First Periodic Evaluation

Groundwater Sustainability Plan for the Las Posas Valley Basin

DECEMBER 2024

FOX CANYON GROUNDWATER MANAGEMENT AGENCY

FIGURE 2-2

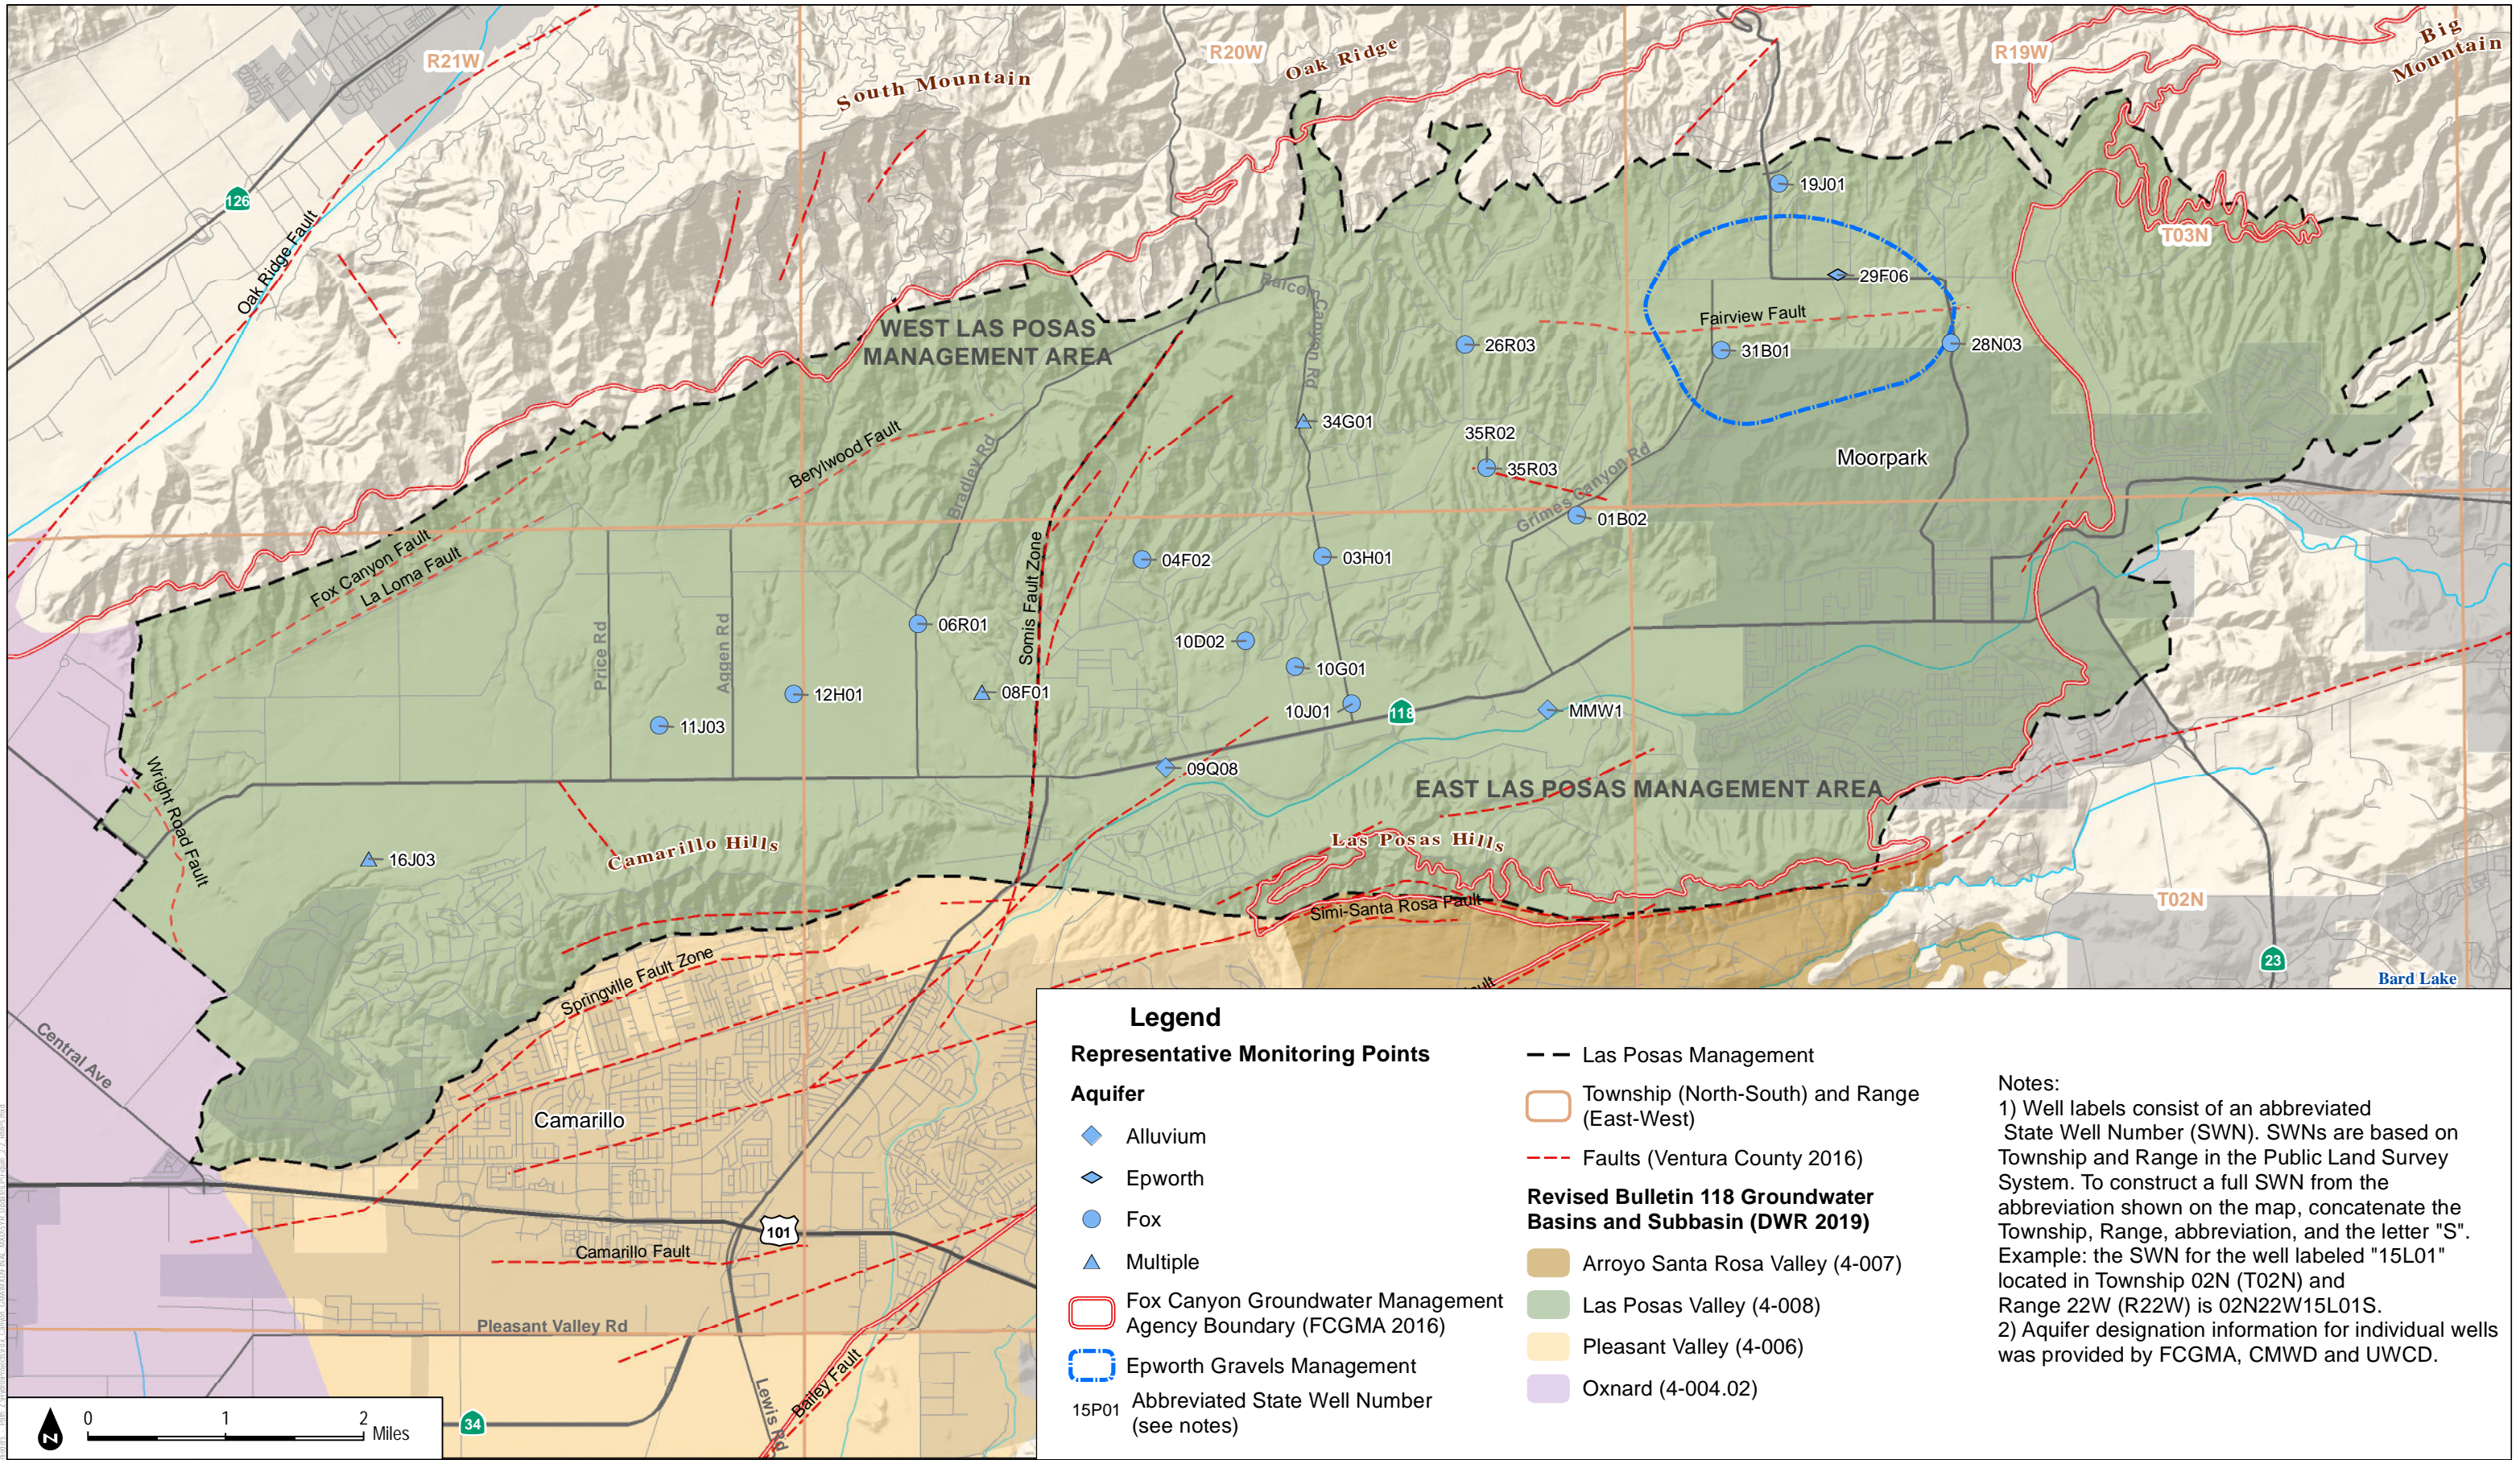
LPVB	7	TAC_BB-TC-4	Consideration should be given to enhancing the RMP network (per review of Figure 2-2): <ul style="list-style-type: none"> ▪ Western WLPMA – there is no RMP for the Fox Canyon Aquifer ▪ WLPMA and ELPMA – both areas lack GCA RMPs (potential candidate RPM well is 03N19W30E07-D) ▪ Epworth Gravels – only one RPM (potential candidate for additional RMPs include 03N19W30M02 and 03N19W30E07-S) 	Noted. These areas are identified in the GSP. FCGMA will investigate the inclusion of the recommended wells as RMPs.
LPVB	7	TAC_BB-TC-5	While Zone Mutual Water Company (Zone) is moving forward with the infrastructure improvements described in the evaluation report, Zone has indicated there are potential legal issues that may prohibit or limit Zone's ability to wheel water to non-shareholders. These issues need to be studied along with other opportunities for moving water between WLPMA and ELPMA. Regarding the 500 AFY of water savings associated with converting from scheduled deliveries to on-demand deliveries, this benefit should not be included in the future water supplies for the Projects Scenario because that water savings will be retained as carryover or leased to other water right holders for the benefit of Zone shareholders unless Watermaster creates a financial mechanism to make Zone whole.	Noted. The project description was solicited as part of the FCGMA Board project prioritization process that commenced prior to formation of the TAC. The project description provided by the project proponent was used to incorporate the project into the model for the GSP evaluation. Revisions to the project description are planned for the Basin Optimization Plan.

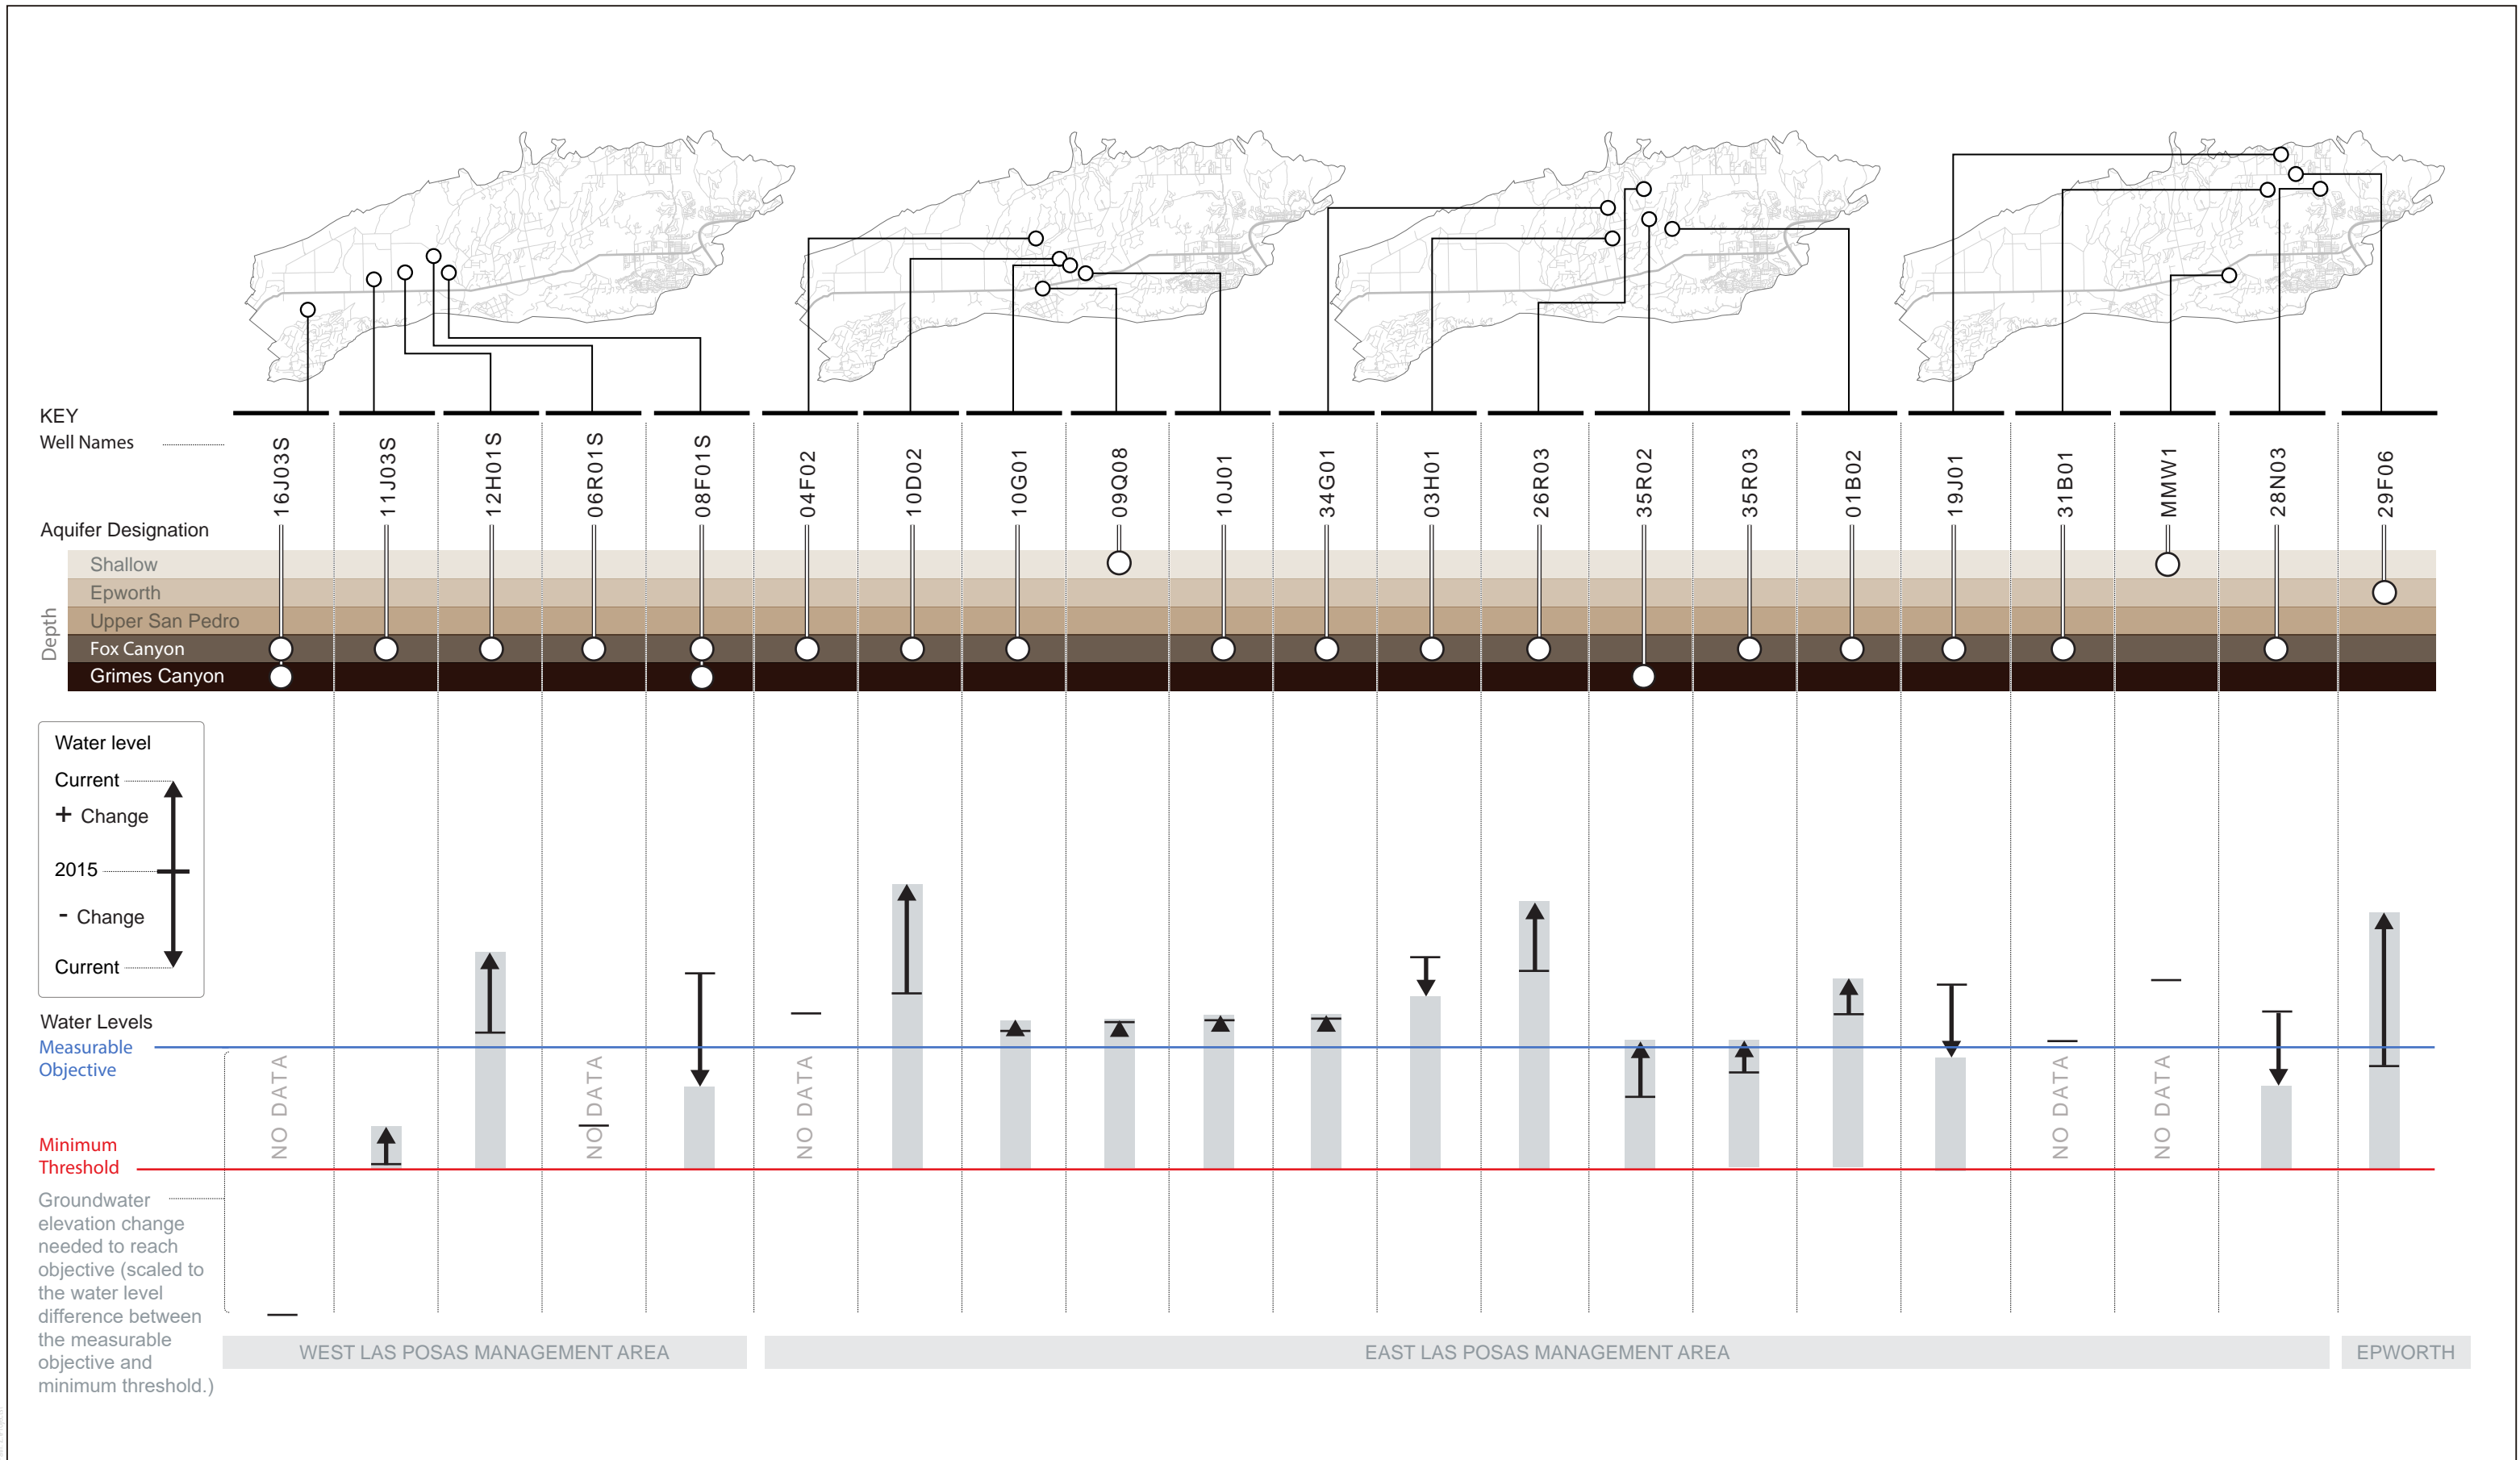
LPVB	7	TAC_BB-TC-3a	Based on Figure 2-4, there does not appear to be any 2024 groundwater level measurements in the western half of the WLPMA. Therefore, it is unclear what data the quoted sentence is based upon	Figure 2-4 only shows the water level changes in the key wells relative to groundwater elevations in 2015, the minimum thresholds, and measurable objectives. Groundwater elevations are measured in wells throughout the monitoring network. The quoted sentence is based on figures 2-7 and 2-8
LPVB	7	TAC_BB-TC-3b	Based on Figure 2-4, there is one well indicating a higher groundwater level in 2024 and one indicating a lower groundwater level in the eastern half of the WLPMA. Therefore, it is unclear what data this statement is based upon.	See above response.
LPVB	7	TAC_BB-TC-3c	Consider instead distinguishing between changes in the pumping depression in the southeastern corner of the WLPMA versus the remainder of the management area, with groundwater levels appearing to be lower in former and higher in the latter.	Text has been revised.

LPVB	7	TAC_BB-EC-8	Per Figure 2-4, groundwater elevations were measured in 16 of the 21 key wells, not 15 as indicated in the text.	Revised.
LPVB	7	TAC_BB-EC-9	WLPMA - LAS estimated 2016-2024 change in storage value is incorrect. S/B -32,970	Revised.
LPVB	7	TAC_BB-EC-10	It is unclear what new information has been incorporated into understanding of recharge areas.	Noted. This is correcting an omission in the GSP.
LPVB	7	TAC_BB-EC-11	Text states "Available data characterizing groundwater extractions in water years 2021 and 2022 indicate that groundwater extractions from the LPVB averaged approximately 42,400 AFY (Tables 4-3 and 4-4)." Per the referenced tables, the value cited in the text should be 40,400 AFY	Revised.
LPVB	7	TAC_BB-EC-12	WY 2022 Epworth Gravels Aquifer extraction value appears anomalously low. Consider investigating and/or footnoting.	This is the correct value, although the reported extraction value had to be estimated from the AMI data and may be lower than the actual volume produced.
